**GOLD STANDARD FOR THE GLOBAL GOALS (GS4GG)
REPORT
-
VERIFICATION**

Project Title:	Panasolar Photovoltaic Project
Monitoring Period:	04/11/2019 to 30/11/2023 (both days included)
GS project ID:	3556
Internal ID:	BELL_GS_VER_24323
Customer:	Panasolar Generation S.A.
Date:	21/08/2025
Revision:	03.0

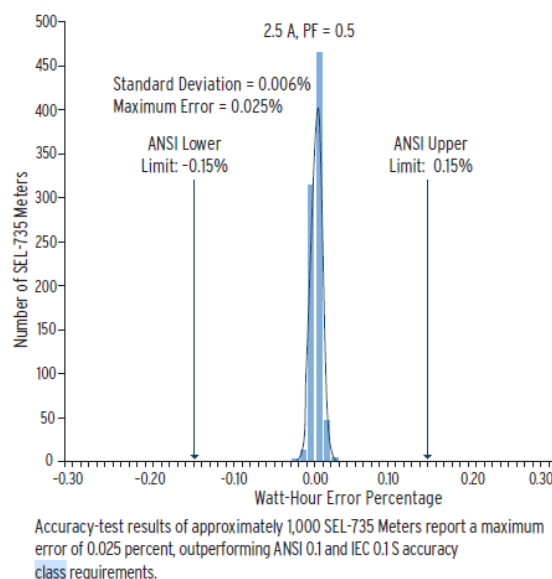
a) Tab "ER Calculation Summary": missing SDG comparison for SDG7 and SDG8 as well as SDG 13

b) Tabs "ER Calculation 2019, 2020, 2021, 2022, 2023": No cross check has been included.

2. MR Updated. The trainings are specified in the monitoring parameters.
3. ER Sheet updated
 - a) SDG comparison added
 - b) Cross check added according to the raw data of the utility report

1. It has been clarified and corrected in the MR. No further discrepancies were identified.
2. Detailed information about the trainings have been defined. No further discrepancies were identified.
3. SDG comparison have been now added and cross check has been also added. No further discrepancies were identified.
